Site Audit Report Delineation and Characterisation Sampling and Review of Remedial Options Former Gasworks Site, Burren Street, Erskineville NSW

14 September 2007

RailCorp Safety & Environment Group

HLA-Envirosciences Pty Limited

Figure 2
Current & Historical Site Layout

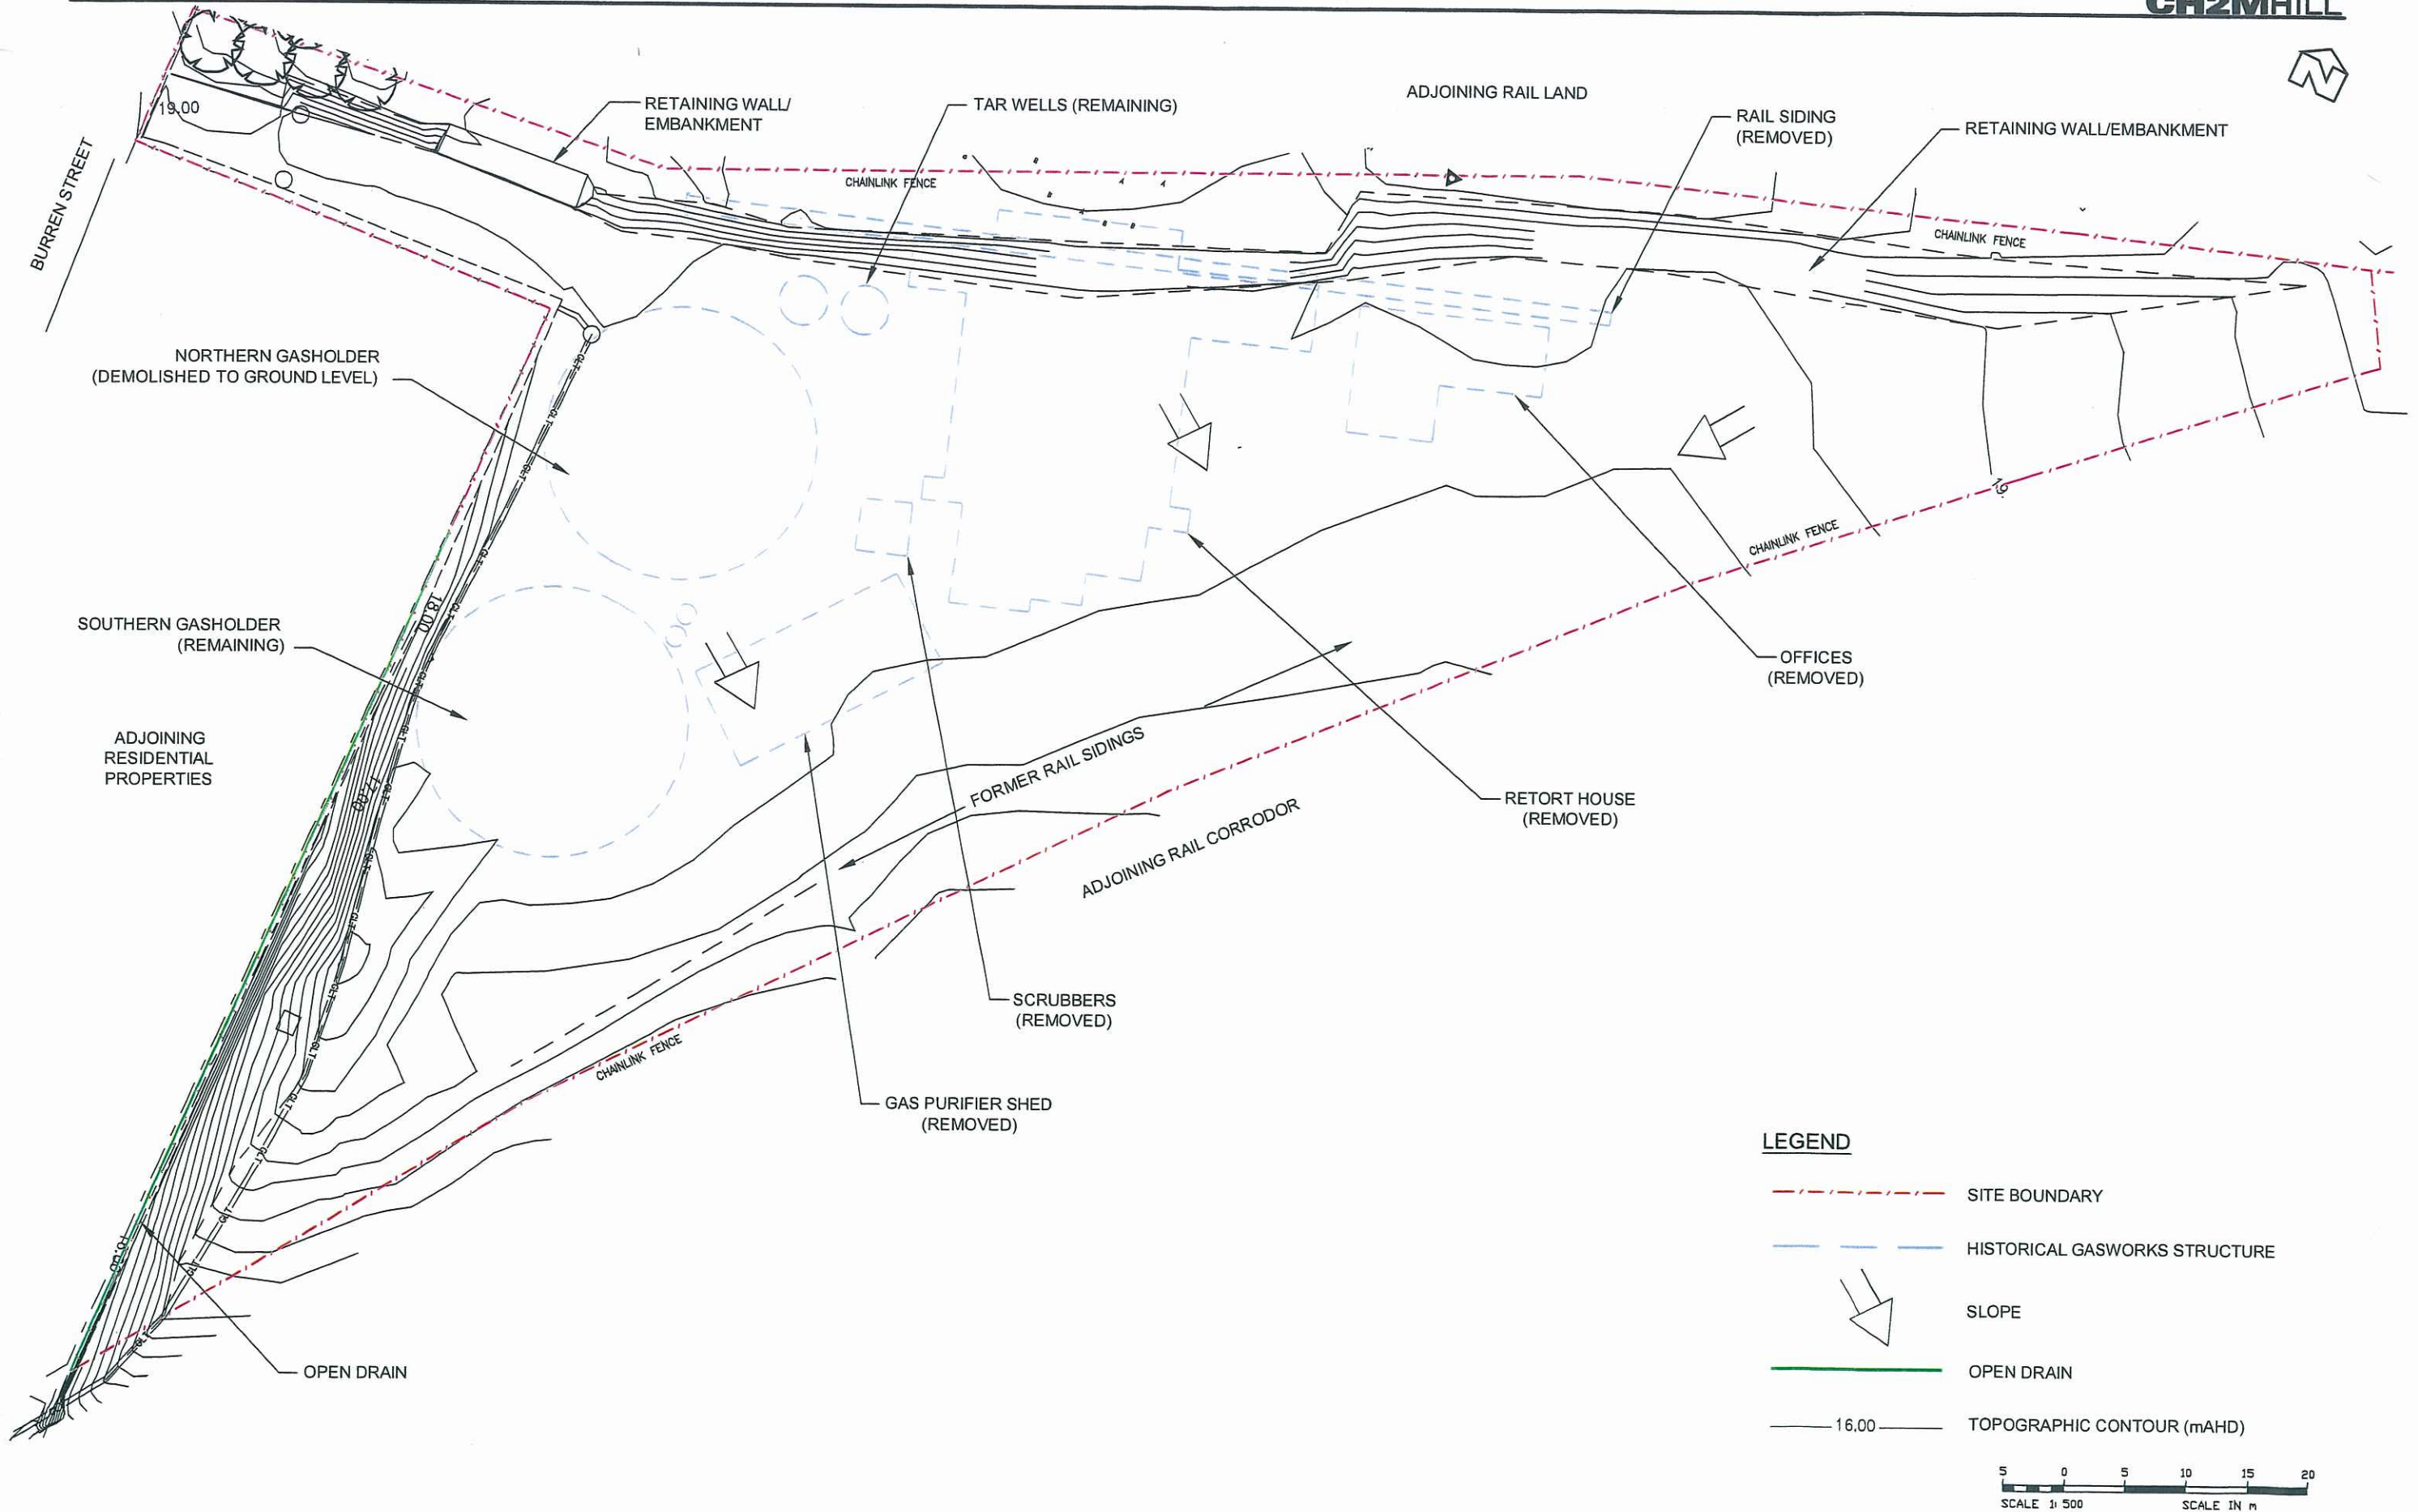
It is the Auditor's opinion that the Report adequately identified the boundaries of the Site.

Figure 3
Stratified Site Areas, Sampling Locations & Cross Section Transects

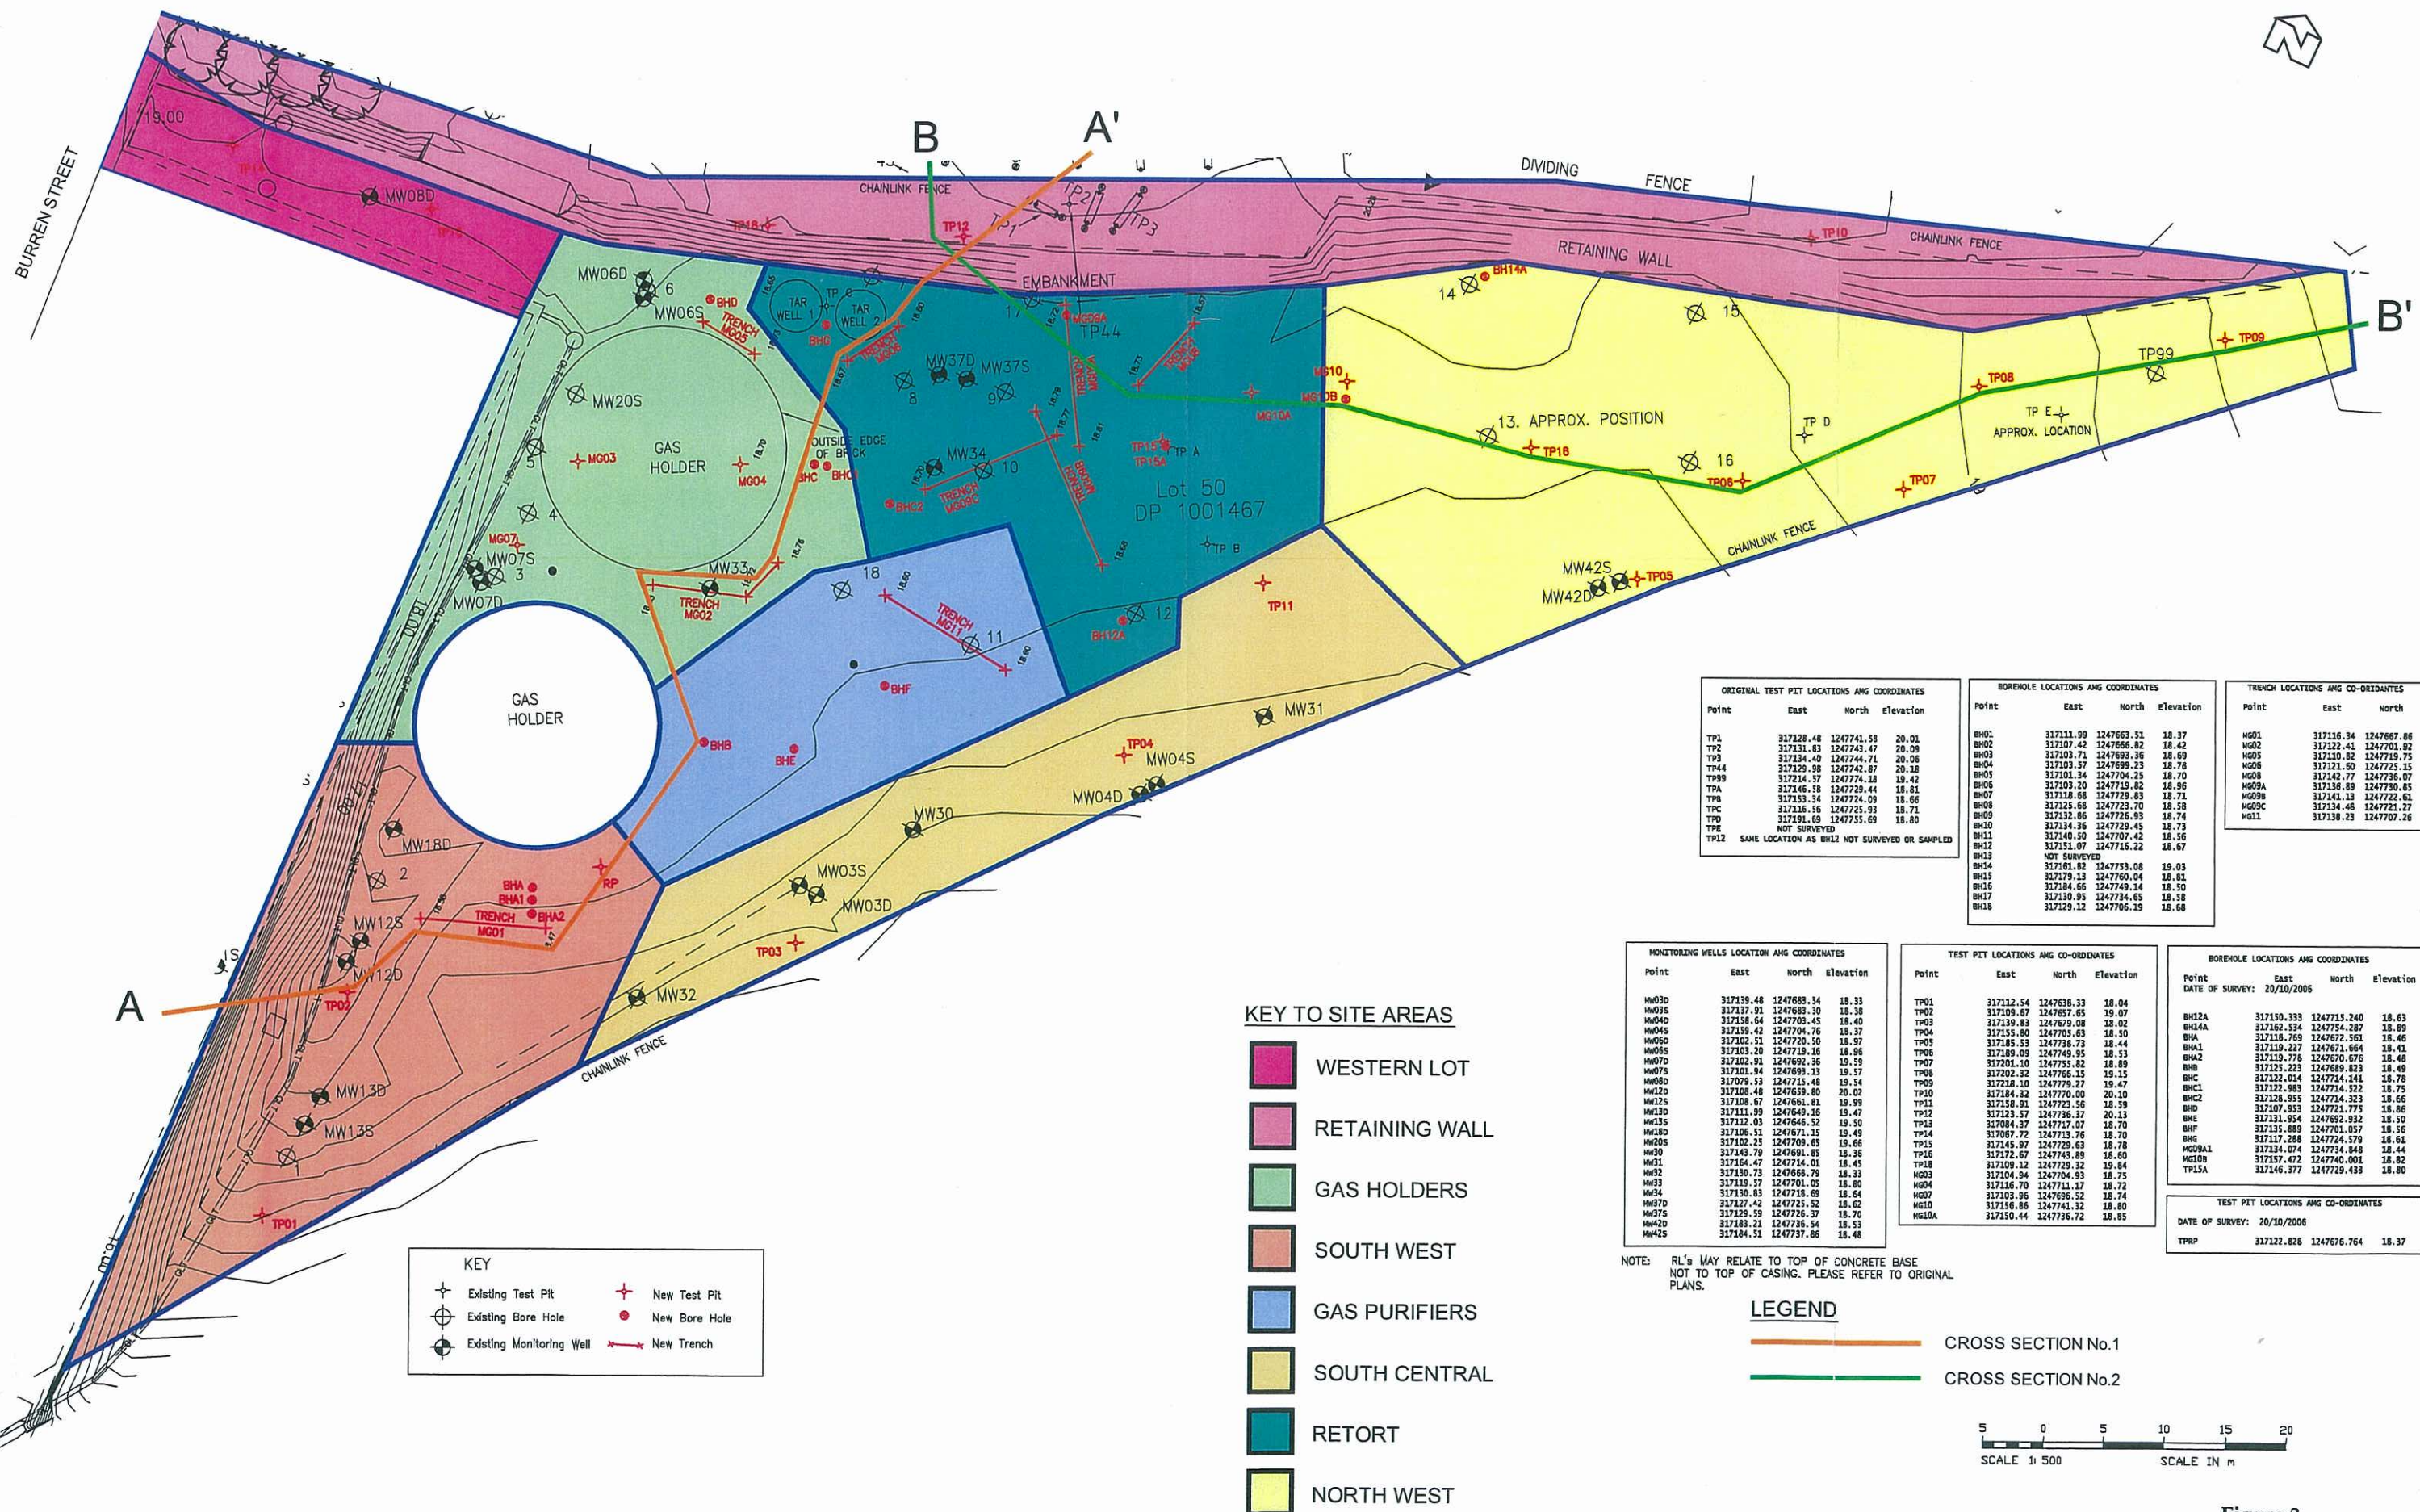
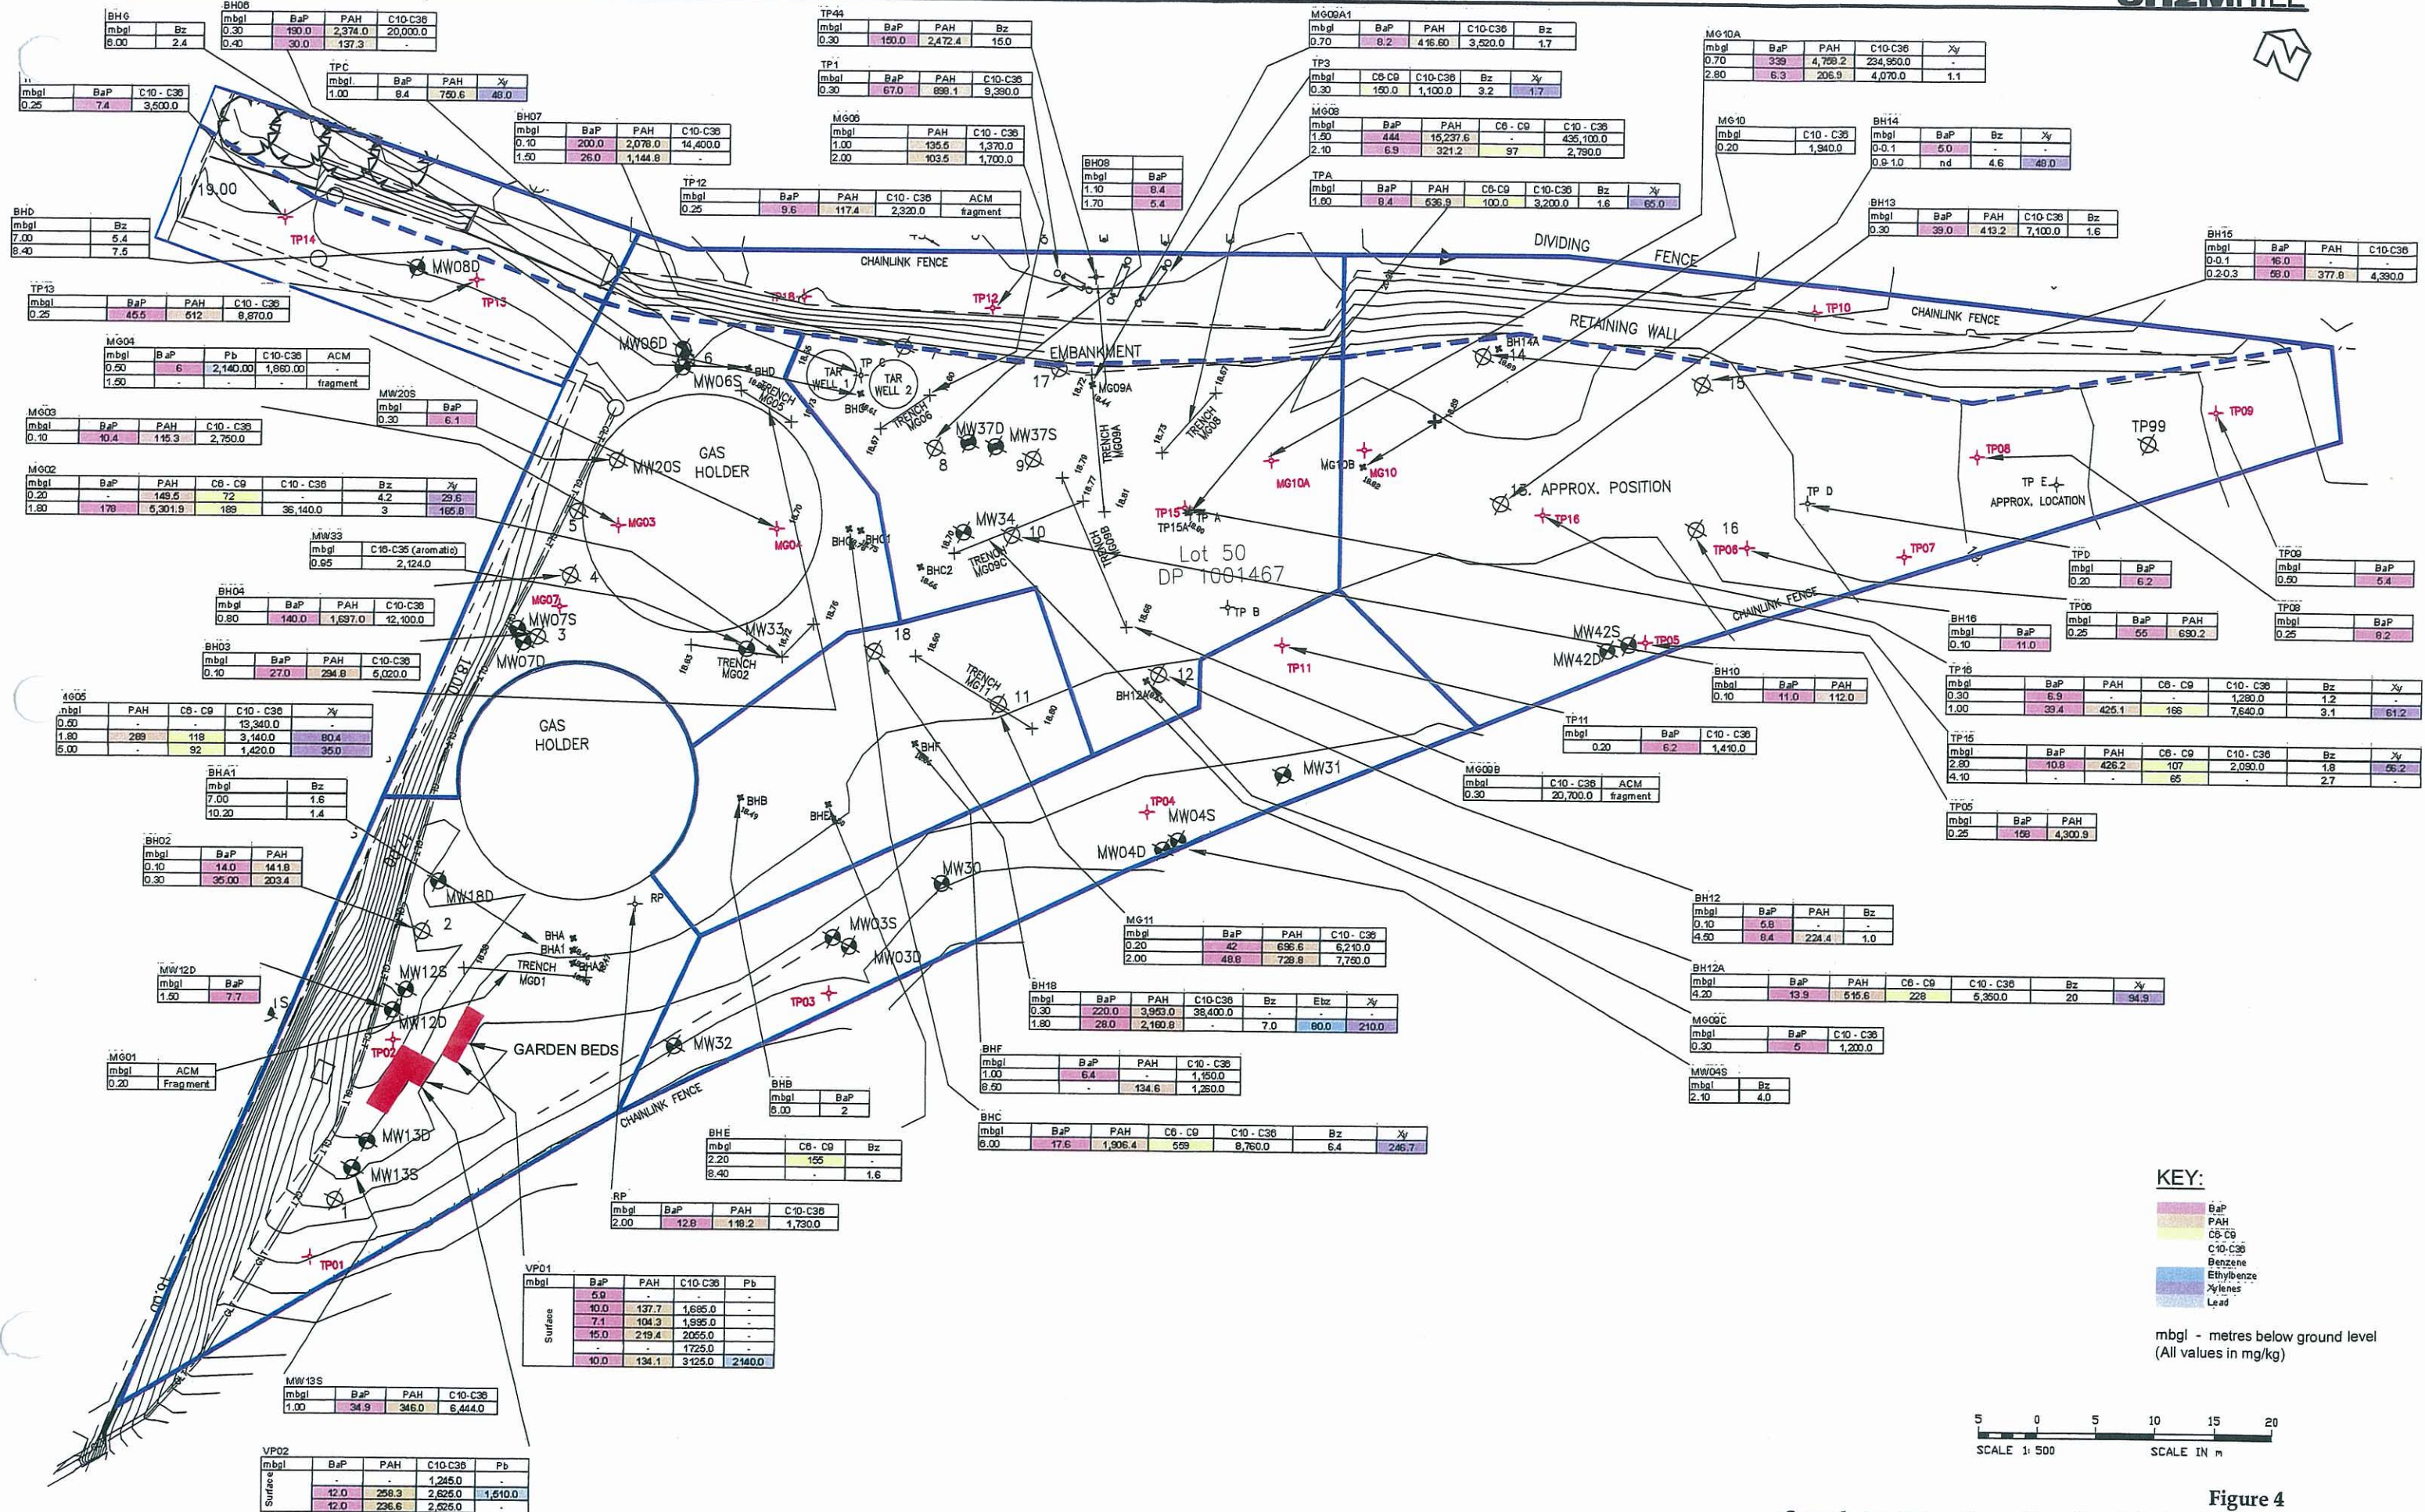
The Auditor notes that on Figure 3 of the Report a typographical error in the Key indicated that the area shaded yellow was defined as the Northwest area when it should have been the Northeast area.
